CITY OF REYNOLDSBURG

DESIGN REVIEW BOARD THURSDAY, NOVEMBER 2, 2017 7:00 PM

DESIGN REVIEW BOARD THURSDAY, OCTOBER 5, 2017 7:00 PM

Re: Generator Enclosure Materials Variance Request
Permit Application Number: 175596
OH FSED Reynoldsburg
6960 East Main St.
Reynoldsburg, OH 43068

elevation - generator enclosure

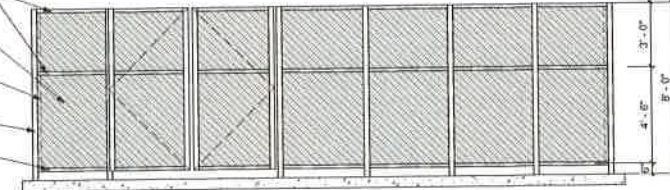
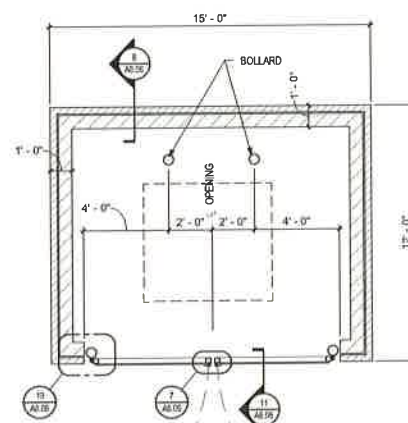
We are seeking a variance for the metal panel material that is being used as an enclosure for the generator at the OhioHealth Freestanding Emergency Department.

For aesthetic and screening reasons we are proposing to use the same corrugated metal panel as installed on the side of the building and mechanical roof screen wall in lieu of a 6' tall chain link fence as prescribed in the Fire Code. The metal panel will provide the means to prohibit public access and a lock on the entry gate will keep the tank secure. Attached to this letter are cut sheets for the proposed material and a current plan of the generator enclosure.
